Process Sheet

Customer	CU-DAR001 Dart Helicopters Services	Drawing Name	STEP REVIEWED <u>07/06/07</u> DATE _____
Job Number	32718-1	Part Number	D3562041
Estimate Number	12576	Drawing Number	D3562 UNDER REVIEW
P.O. Number	N/A	Project Number	N/A
This Issue	5/31/2007	Drawing Revision	A
Prsht Rev.	NC	Material	N/A
First Issue	<u>N/A</u>	Due Date	6/11/2007
Previous Run	29411	Qty:	<u>4</u>
Written By	<u>JLM</u>	Um:	Each
Checked & Approved By	<u>JLM</u>		
Comment	Est Rev:A New Issue 06-11-09 JLM

DESIGN		DRAWN BY	DART AEROSPACE LTD	
CHECKED	APPROVED		DRAWING NO.	HAWKESBURY, ONTARIO, CANADA
DATE			TITLE	SCALE
07.01.15			D3562	SHEET 1 OF 1
A	06.09.26		STEP ASSEMBLY	NTS
B	07.01.15		ARMS NOW RIVETED TO STEP	NTS

D3562-041 LH STEP ASSEMBLY (SHOWN)

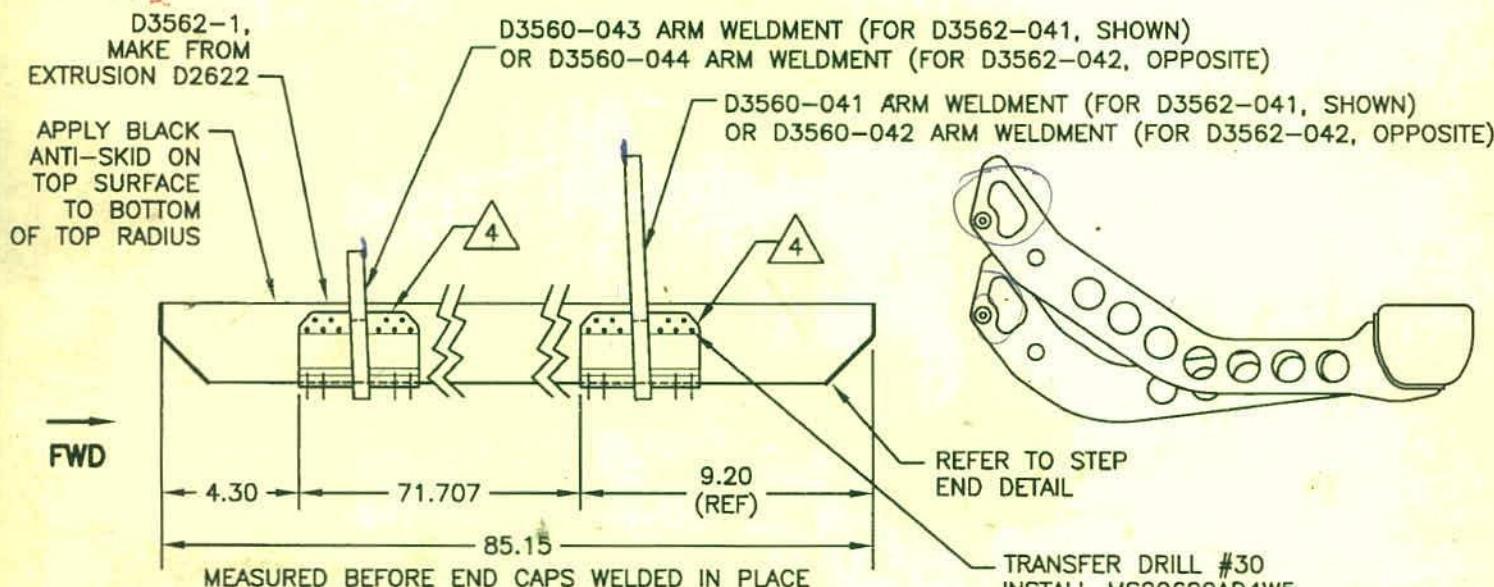
W/O:		WORK ORDER CHANGES					
DATE	STEP	PROCEDURE CHANGE	By	Date	Qty	Approval Chief Eng / Prod Mgr	Approval QC Inspector
07.06.07	11	Remove qty(2) MS20600AD4W RIVETS TOTAL QTY NOW 34 REF. MARKED-UP DWG & DS EMAIL.				IP 07.06.07 P/C 051042	070607

MAGNAIRND

P07.06.07

REF DS EMAIL

For the D3562-041/-042 step weldment, as discussed. They want to switch from Sikaflex to Magnabond, and powder coat after final assembly.

As part of this change, the D3560-XX arms won't be powder coated, and the D2808 Bushing won't be assembled until after final assembly of the step weldment.

For the D3562-041/-042 Step Assembly, we need to remove qty(1) rivet from each D3560-XX Arm weldments attachments for manufacturability. There will be a total qty(34) MS20600AD4 rivets instead of qty(36) per step. The rivet will be removed from the side surface of the step. Remaining shear would be 350 lbs x 16 rivets = 5600 lbs per arm attachments.

As we have discussed previously, this is acceptable as long as the Magnabond doesn't break down.

As we discussed, I think this change is acceptable without further qualification.
